Director's Report

Project Name: Edendale Crossing

Description: Request for reconsideration of preliminary site plan

RE: Edendale Crossing- Preliminary Site Plan Review – 4th Review

SCALE 1" = 80'
 SHEET 3 OF 19
 KE 2025.010

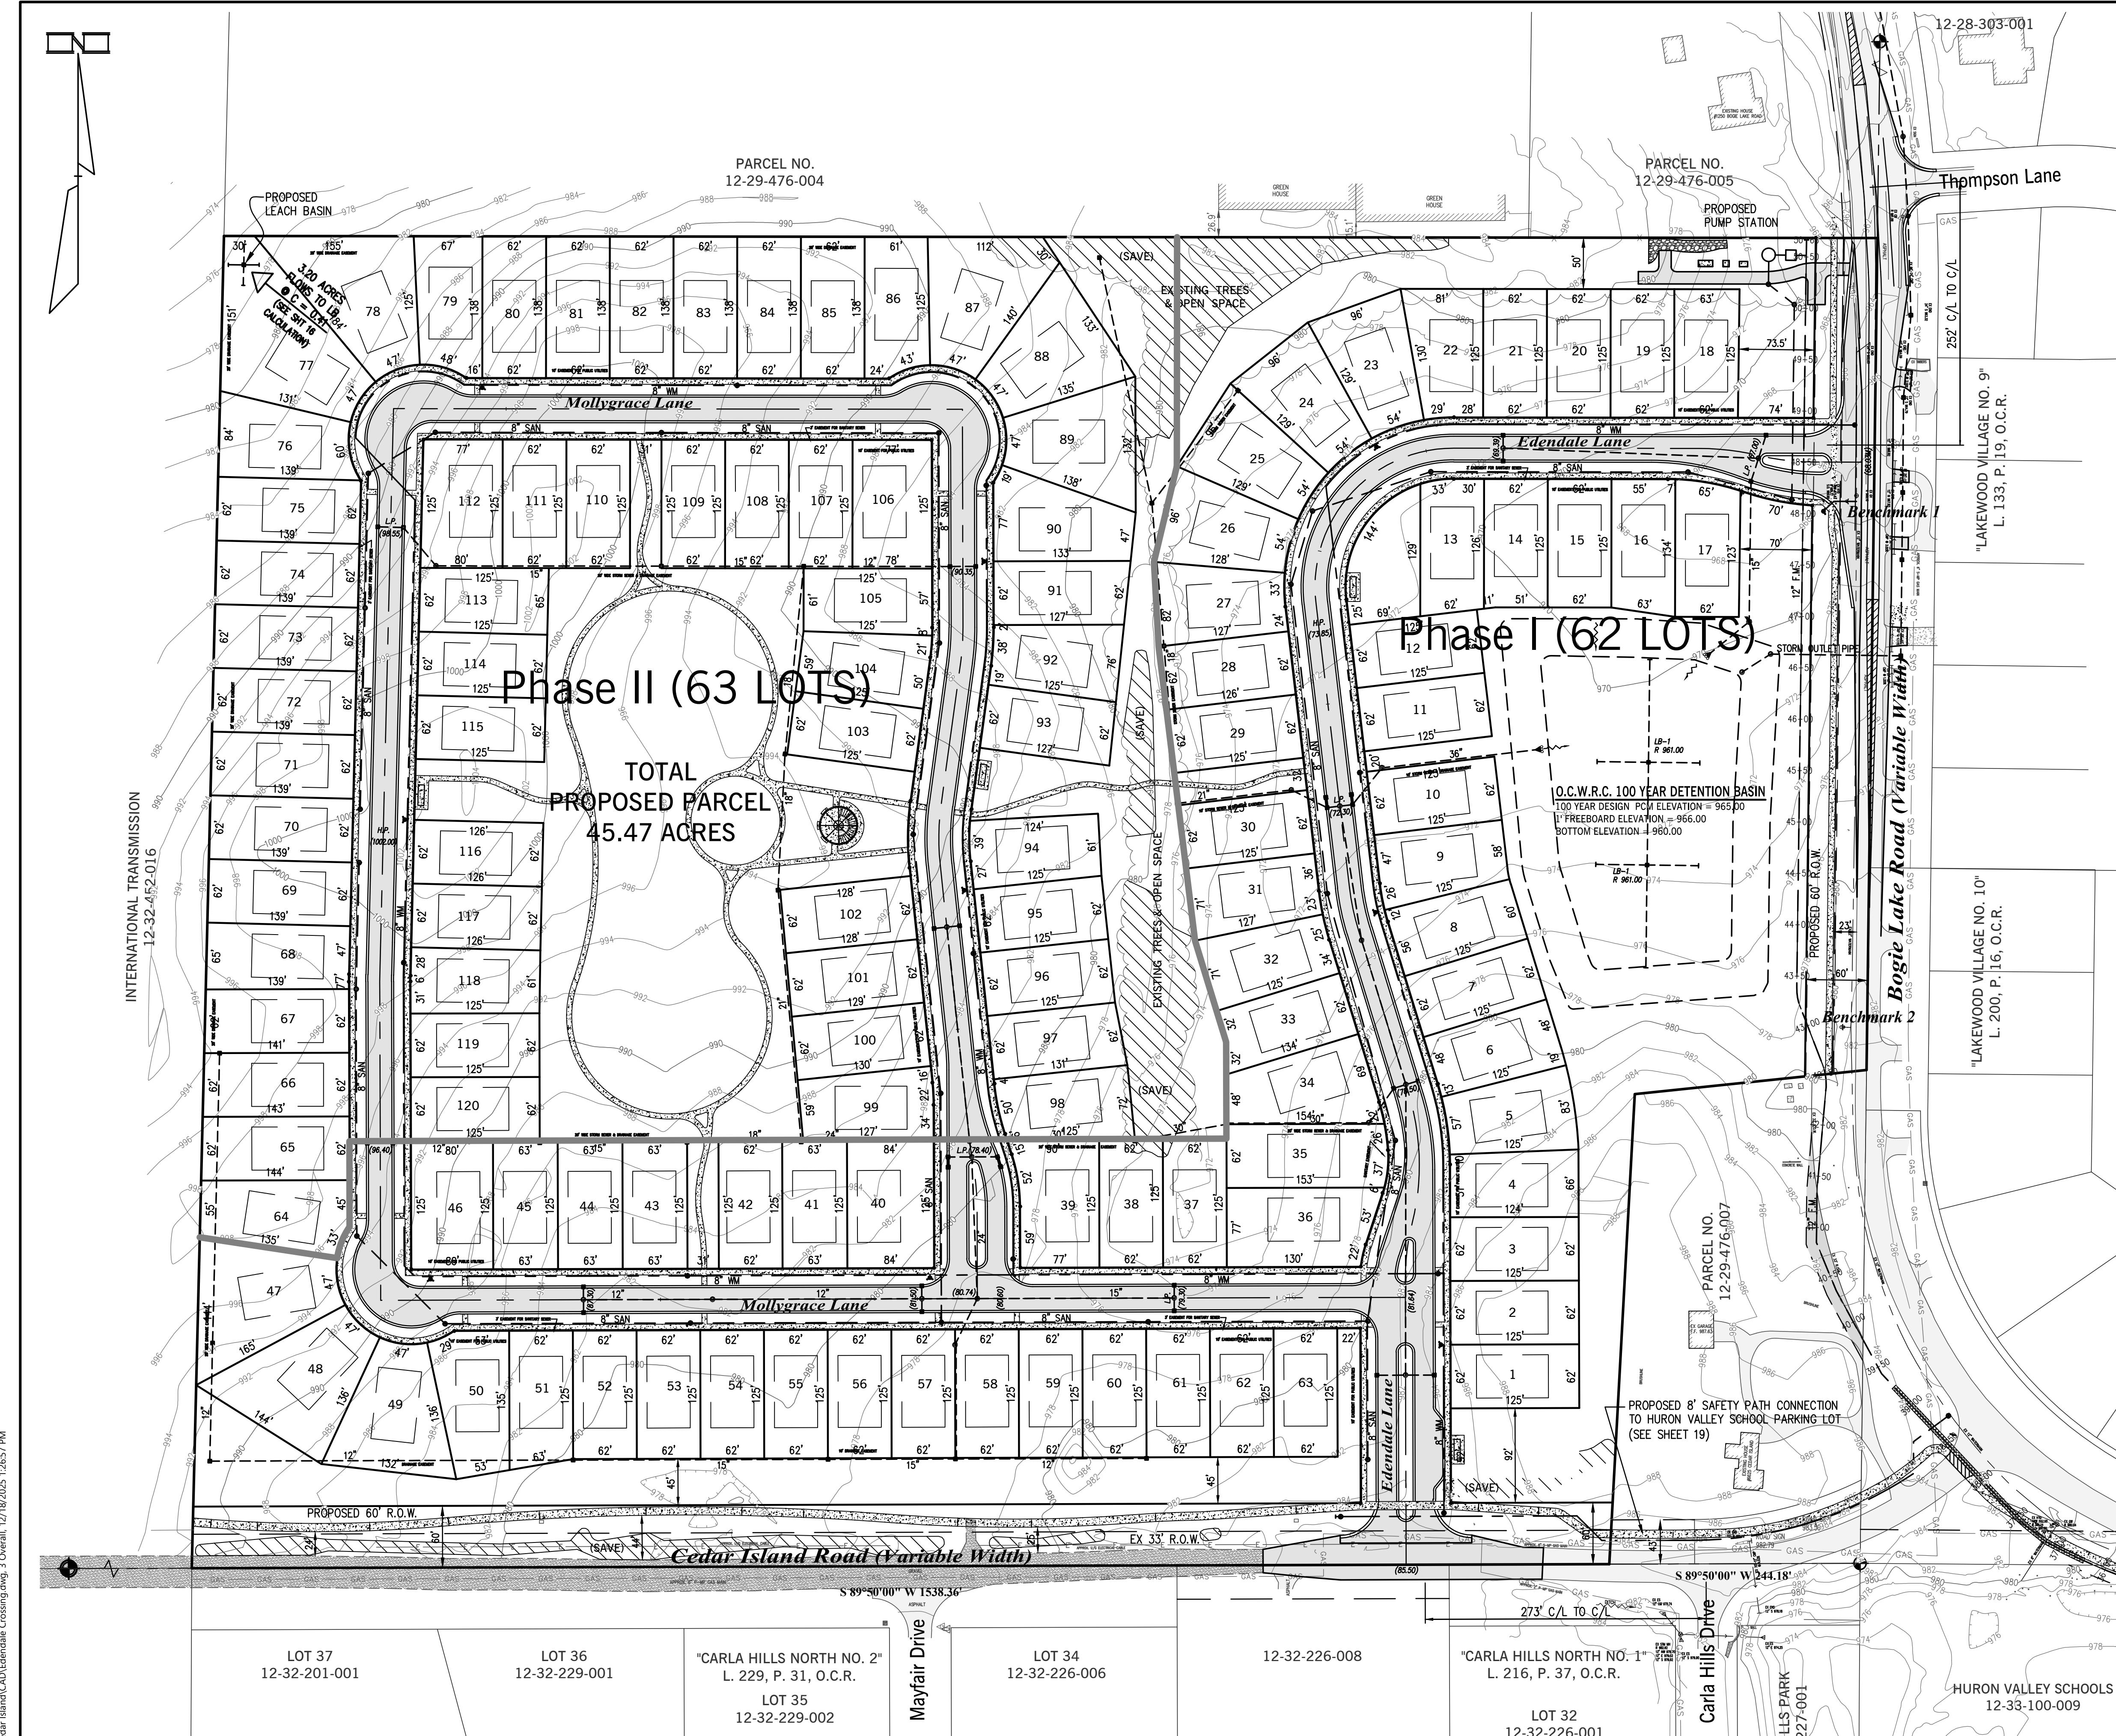
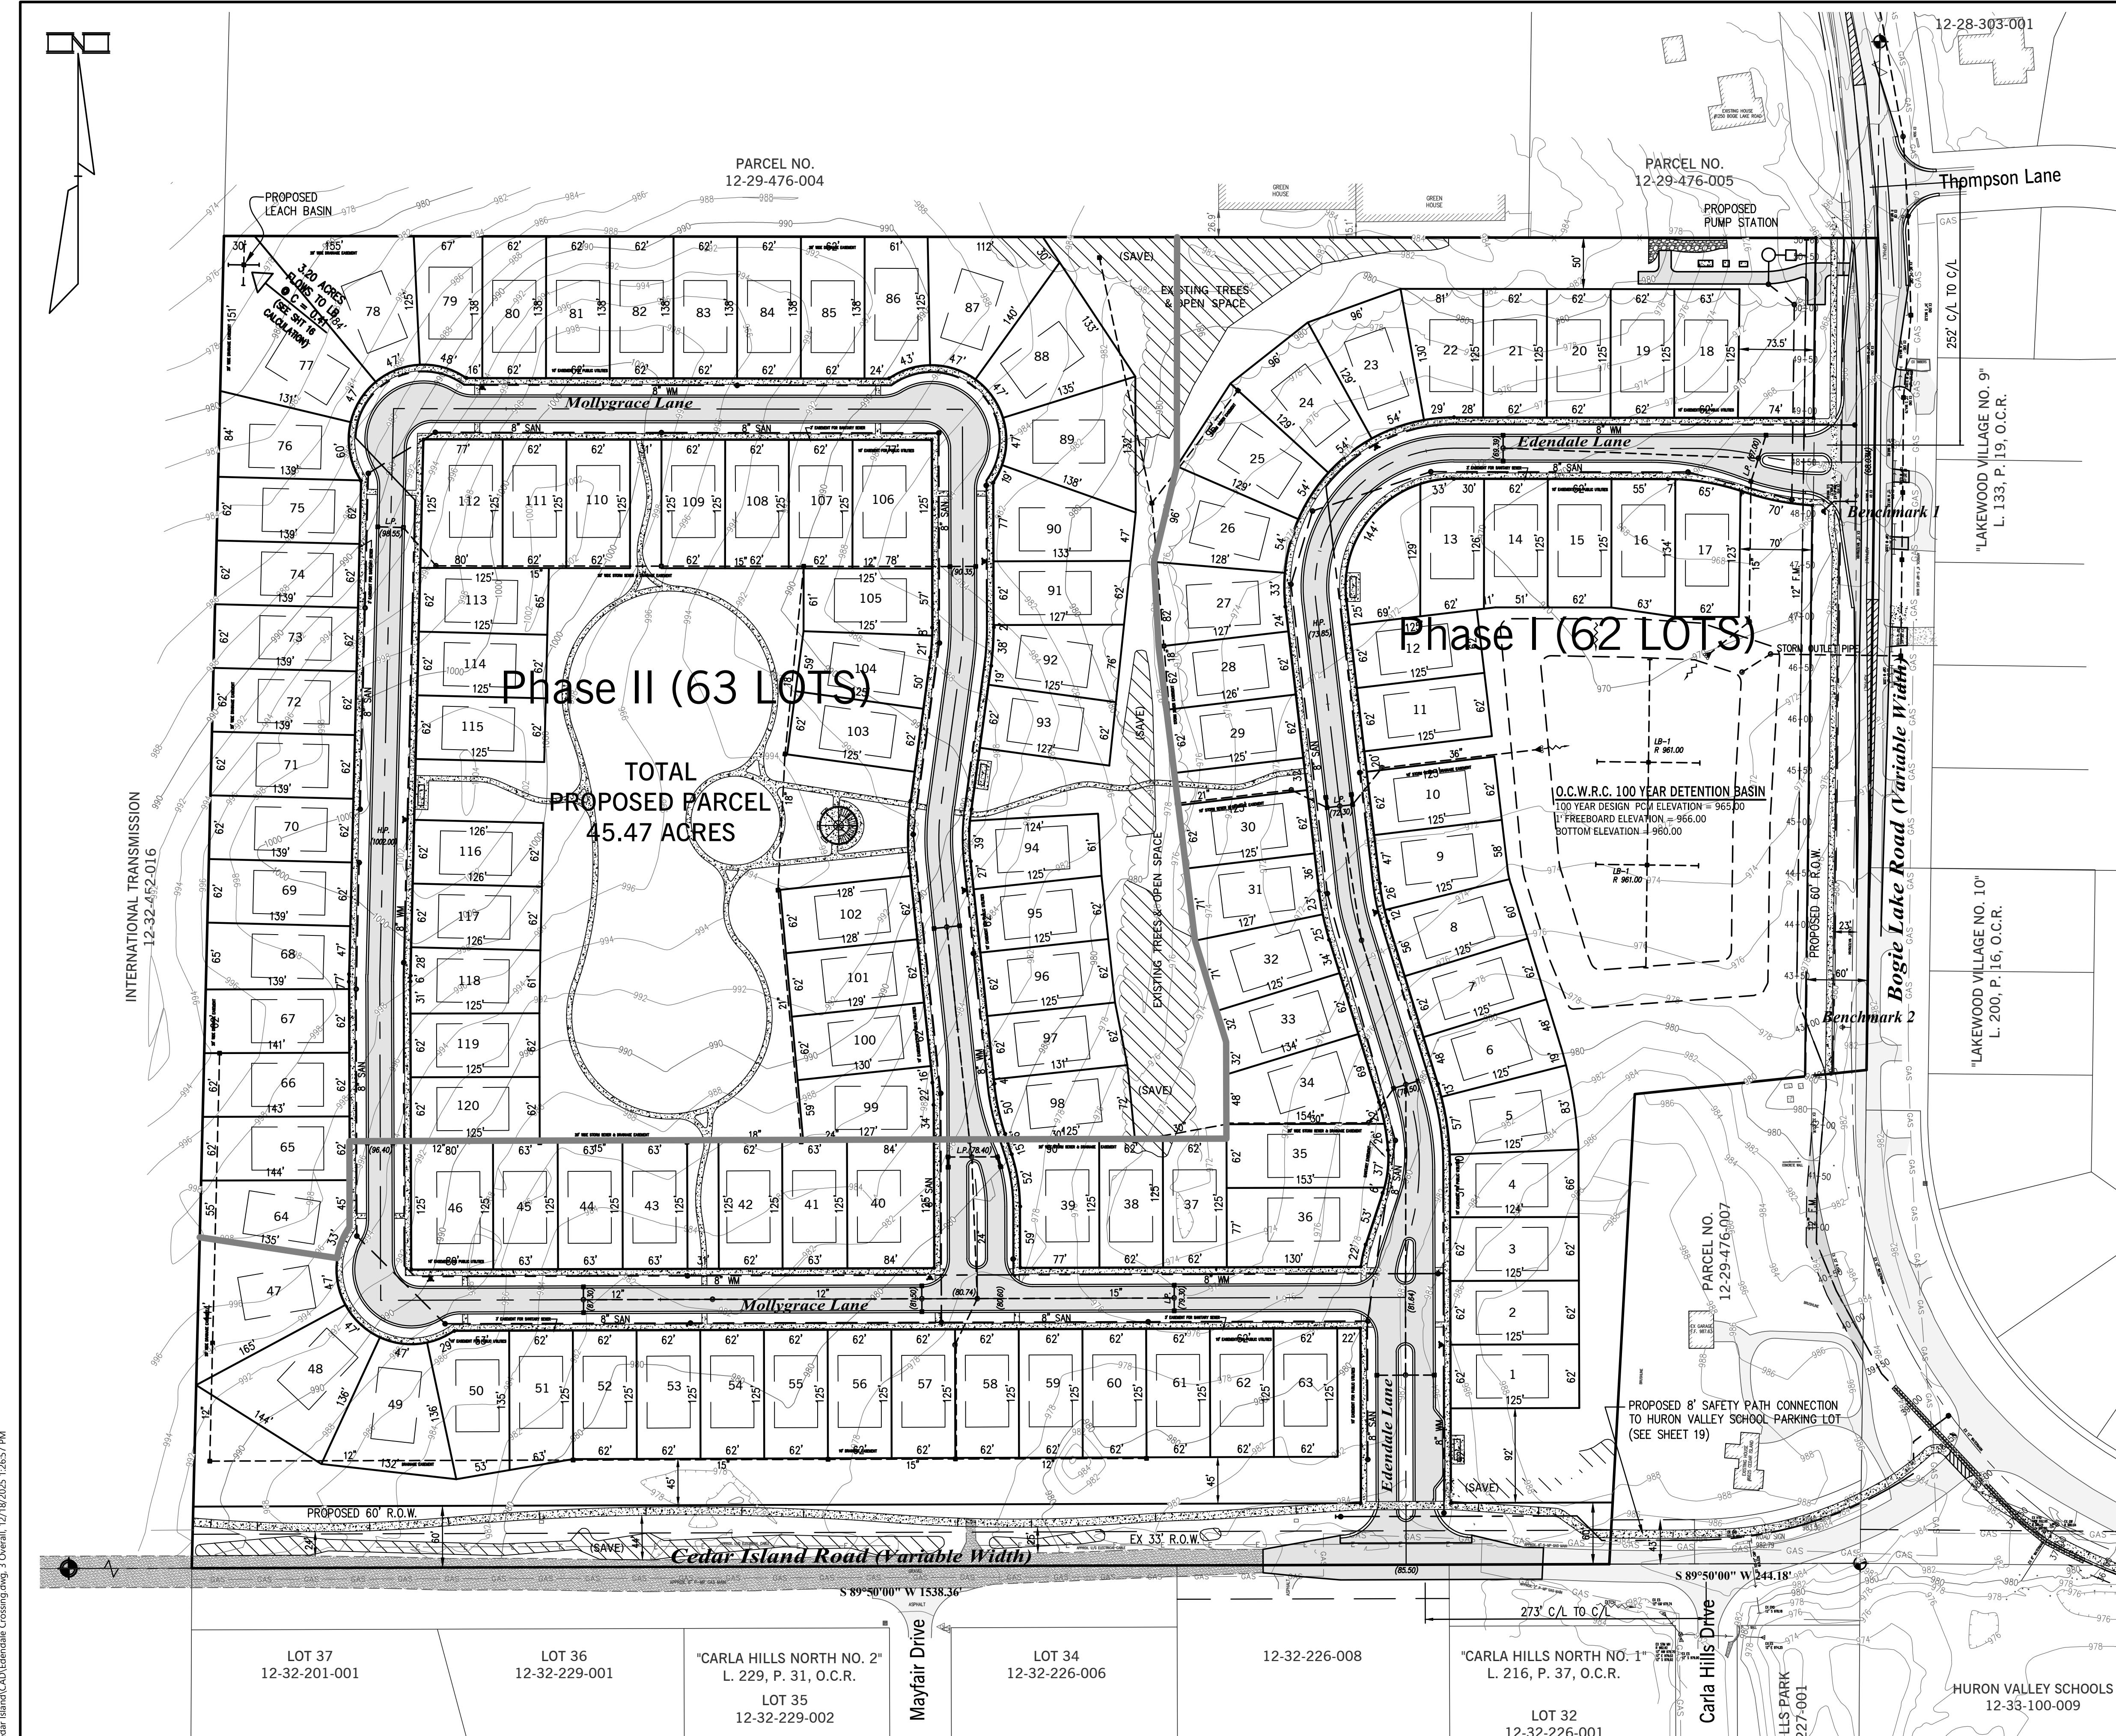
Sheet 3 of the site plan indicates the project will be implemented in two phases. Phase 1 will focus on portions of the site adjacent to Bogie Lake and Cedar Island Roads. Phase 2 fill out the northwestern portion of the site. Sheet 3 outlines the previous unit count for phasing and should be updated.

- 1) *A schedule for the proposed phases is required. Sheet 3 outlines the previous unit count for phasing and should be updated.*
- 2) *The proportions of brick and siding proposed on the façade of the units is complementary, however it is recommended that the brick also be included in a similar proportion on the side and rear elevations.*

Per Sheet 3, it appears there is an opportunity that the Cedar Island boulevard access and Mayfair Drive could be aligned. This modification would likely put the access point in conformance with distance from existing drive regulations and put the intersection further from Bogie Lake Road. The CIS states the applicant does not feel this is warranted because the area along Cedar Island Road in question is a school zone and therefore traffic moves at a slower rate of speed. If this modification is not made, the proposed drive at Cedar Island will need a waiver from the Planning Commission per Section 6.4.F. RCOC approval will be required for the proposed access drive.
